SCHEMATIC OF 90711 VFO.
FIRST MADE FOR 90711

DESIGNED BY R.W.C. CHECKED BY E.G.J.
DRAWN BY H.COTTERLY JR APPROVED
JAMES MILLEN MFG. CO., INC. DATE
MALDEN, MASS., U.S.A. M90711 3-10-48

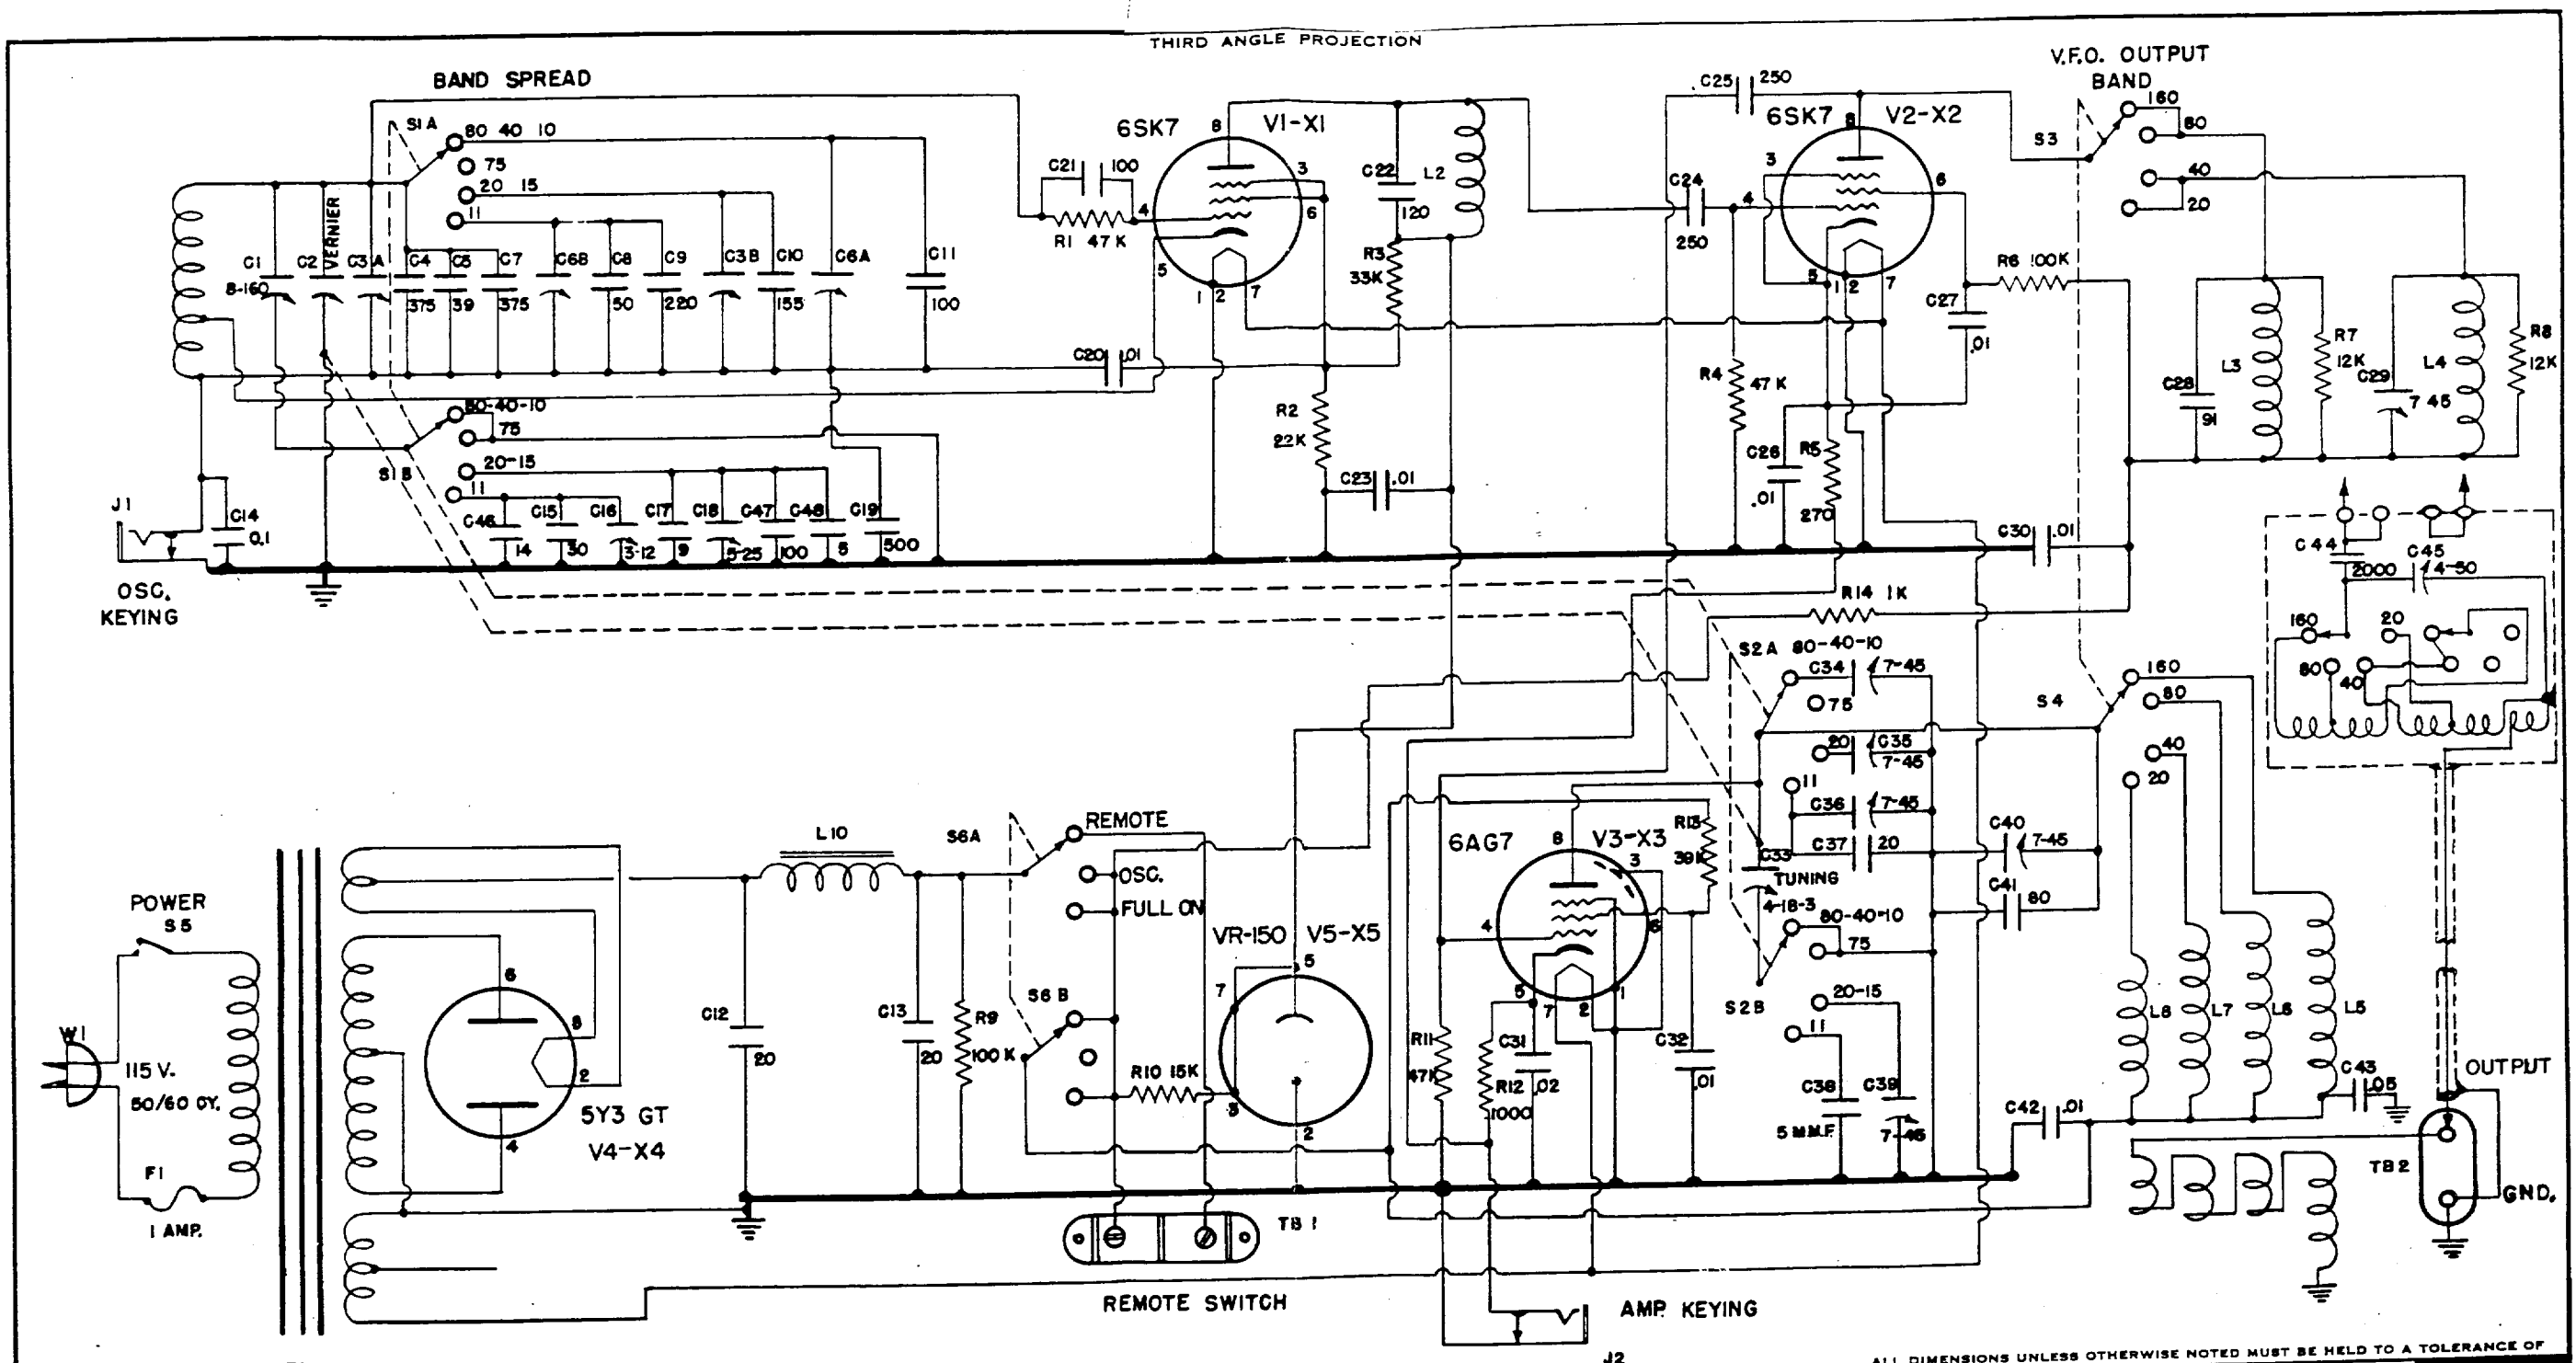
- 12-7-48 (3) V2 B Supply was connected directly to V3 B Supply
- 12-7-48 (2) C17 added) output changed C48 - 5 mmfd added
- 12-7-48 (1) C17 was 9mmfd. added contacts on output S4
